93-157r0

To: X3T9.2 Membership
Editor: John Geldman, Cirrus Logic
Date: September 29, 1993

Subject: Proposed 22 MByte/Sec ATA Timing Extension

FIGURE 1: Multiword DMA Timing Diagram

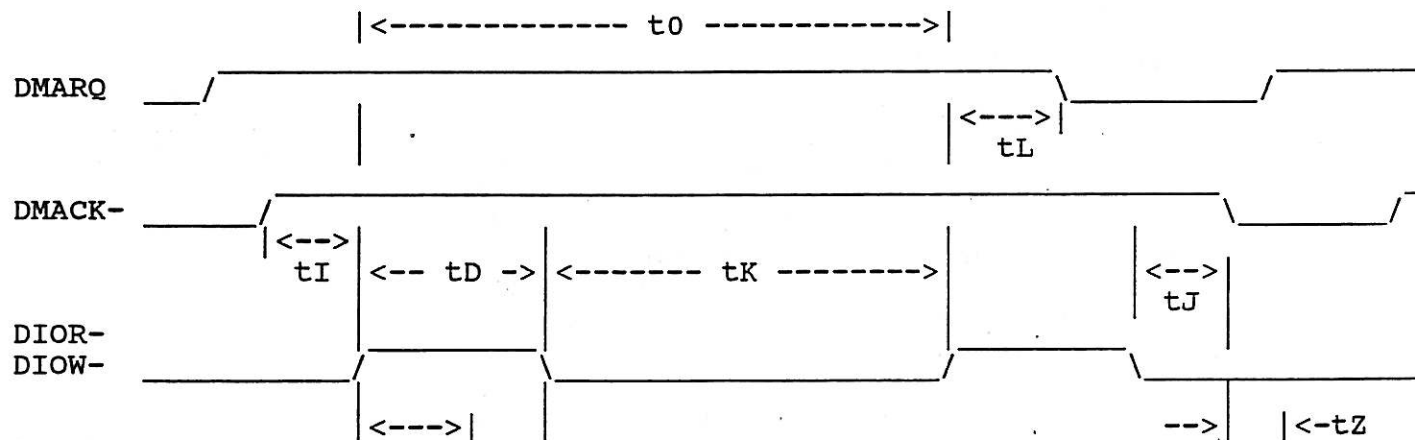
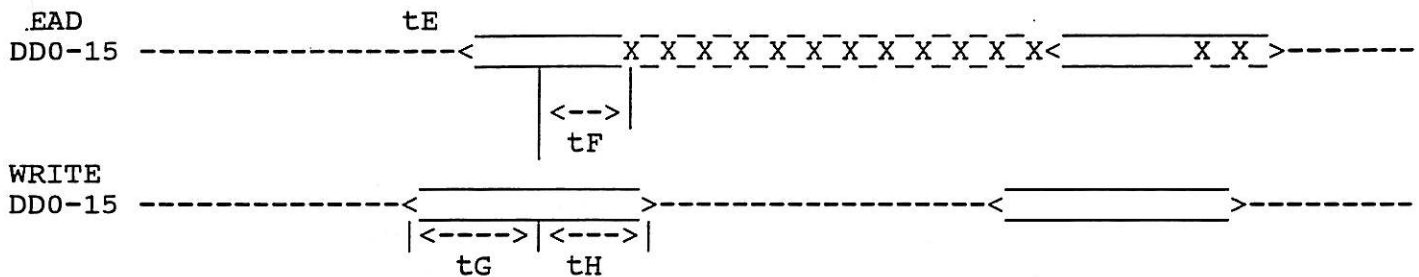
New One new Multiword DMA Transfer Modes are is defined and identified as Mode 1 and Mode 2. The timing parameters associated with Multiword DMA Transfer Mode 1 and Mode 2 are defined in Table 1. Peripherals reporting support for Multiword DMA Transfer Mode 1 must also support Multiword DMA Transfer Mode 0. Peripherals reporting support for Multiword DMA Transfer Mode 2 must also support Multiword DMA Transfer Mode 1 and Mode 0. Figure 1 shows the basic timing for Multiword DMA Transfers and is included to show the new timing parameter t_2 .

Multiword DMA timing parameters	Mode 1 nsec		Mode 2 nsec	
		Min	Max	Min	Max
t0	Cycle time	**		**	
tC	DMACK- to DMREQ delay		---		---
tD	DIOR-/DIOW- 16-bit	80		50	
tE	DIOR- data access		60		30
tF	DIOR- data hold	5		5	
tF	DIOR- data hold (1)		n/a		n/a
tG	DIOW- data setup	30		20	
tH	DIOW- data hold	15		5	
tI	DMACK to DIOR-/DIOW- setup	0		0	
tJ	DIOR-/DIOW- to DMACK hold	5		5	
tKr	DIOR- negated pulse width	50		25	
tKw	DIOW- negated pulse width	50		25	
tLr	DIOR- to DMREQ delay		40		30
tLw	DIOW- to DMREQ delay		40		30
tZ	DMACK- to tristate (2)		25		25

FIGURE 2: PIO Timing Diagram{tc "Figure 2 PIO Timing Diagram" \f figures \1 2}

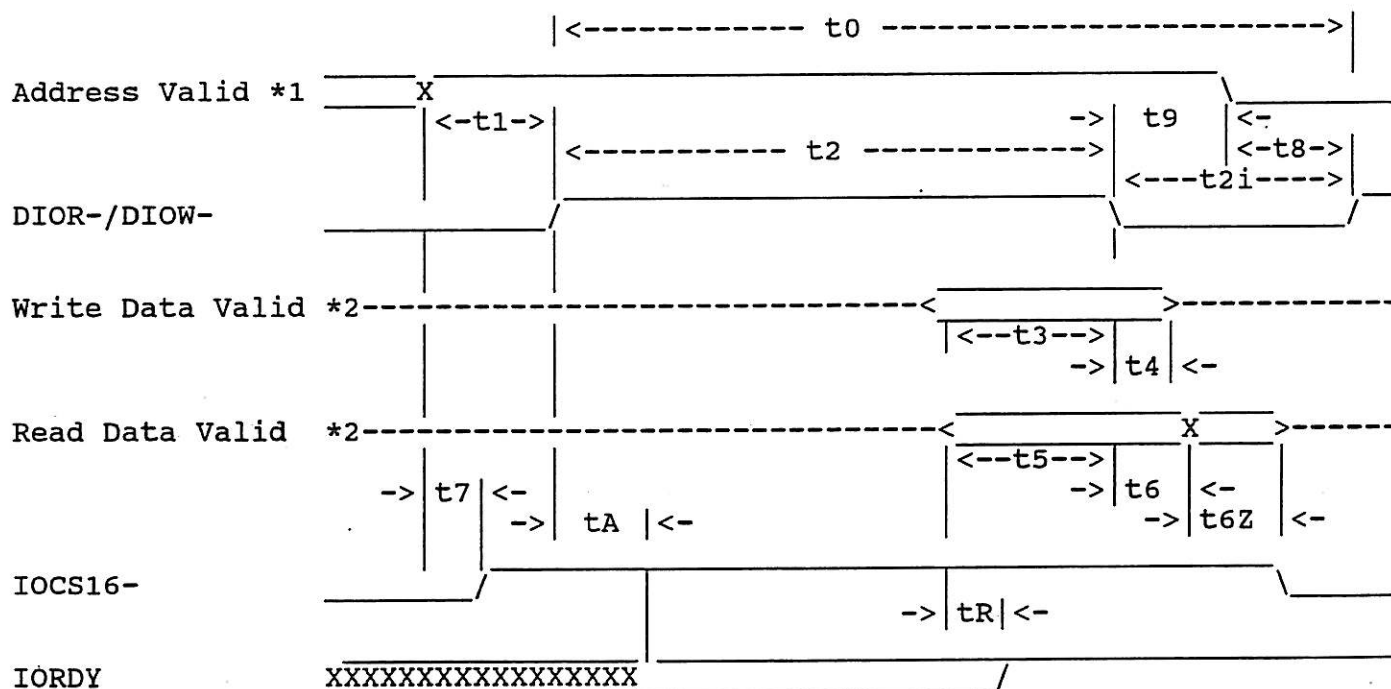
New One new PIO Transfer Modes are is defined and identified as Mode 3 and Mode 4. The timing parameters associated with PIO Transfer Mode 3 and Mode 4 are defined in Table 2. Peripherals reporting support for PIO Transfer Mode 3 or Mode 4 must power up in a PIO Transfer Mode compatible with the existing ATA standard. Figure 2 shows the basic timing for PIO Transfers and is include to show the a new timing parameters t_{2i} , t_{6Z} and t_R .

PIO timing parameters	Mode 3 nsec		Mode 4 nsec	
		Min	Max	Min	Max
t_0	Cycle time (4)	**		**	
t_1	Address valid to DIOR-/DIOW- setup	30		20	
t_2	DIOR-/DIOW- 16-bit (4)	80		50	
	Pulse width 8-bit (4)	80		50	
t_{2i}	DIOR-/DIOW- recovery time (4)	70		25	
t_3	DIOW- data setup	30		20	
t_4	DIOW- data hold	10		5	
t_5	DIOR- data setup	20		20	
t_6	DIOR- data hold	5		5	
t_6	DIOR- data hold (1)		n/a		n/a
t_{6Z}	DIOR- data tristate (2)		30		30
t_7	Addr valid to IOCS16- assertion (5)		30		30
t_8	Addr valid to IOCS16- negation (5)		30		25
t_9	DIOR-/DIOW- to address valid hold	10		5	
t_A	IORDY Setup time (3)	35		20
